ECR/ECO NUMBER WC2262 --- SERVICE INFORMATION --- PRINTED 12.11.92

SUBJECT Use 8375 instead of 8372 AGNUS requires rework.

MODEL A2000

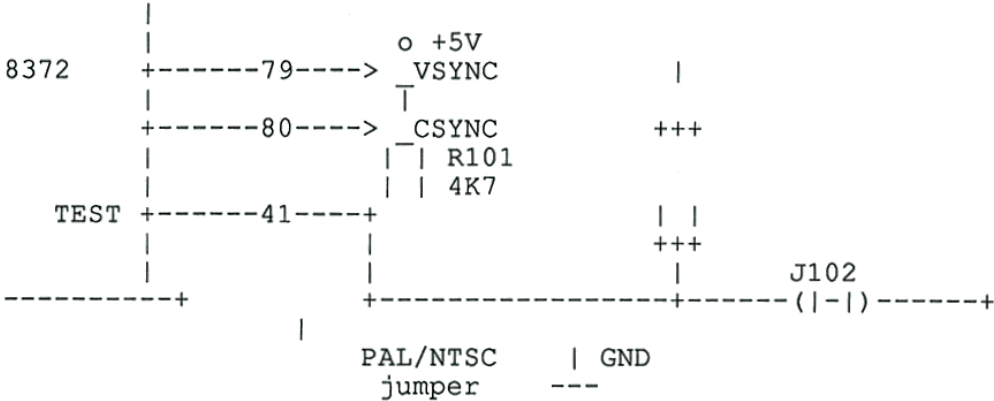
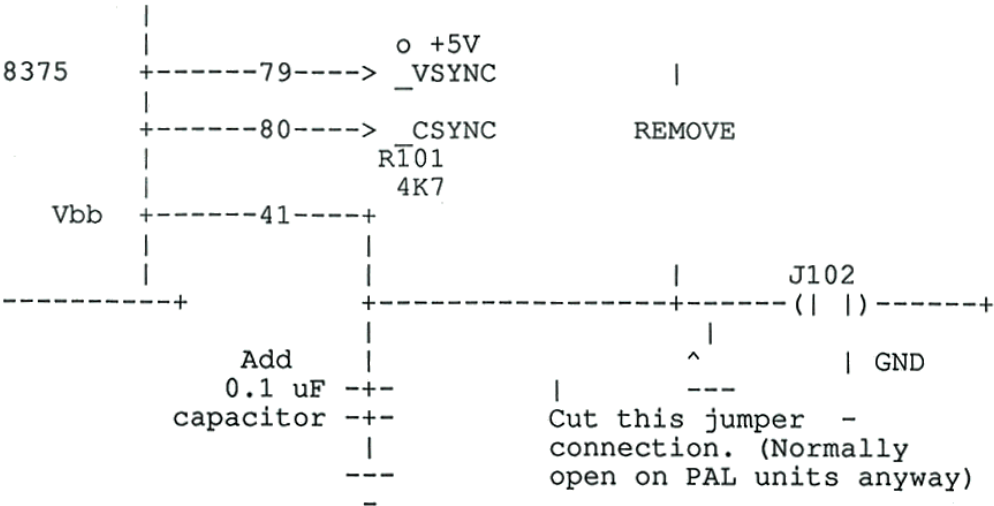
```
> ----- REWORK INSTRUCTIONS: -----
>
> New AGNUS (8372 => 8375)
> =====
>
> (From ECR WC2262):
> -----
>
> The 318069-029 AGNUS chips has been replaced by 318069-16 (PAL) and
> 318069-17 (NTSC). These version have Vbb connected to what was the
> NTSC/PAL pin of the -029.
>
> Rework when upgrading:
> -----
> An 0.1 uF must be added between this Vbb pin and ground on the PCBA.
> R101 (4.7Kohm) has to be removed and J102 cut.
>
> MY NOTE: The old AGNUS (318069-029) was a 'two-versions-in-one' chip,
> that could be set to PAL or NTSC by J102. This is not possible
> with the new chips. Thus two versions are now available.
```

ISSUE 318069-029 AGNUS has been replaced by 318069-16 (PAL) and 318069-17 (NTSC). These versions have Vbb connected to what was the NTSC/PAL pin of the -029.

ACTION A 0.1 capacitor uF must be added between this pin (41) and ground.  
Also the R101 (4k7 ohms) must be removed and J102 cut open.
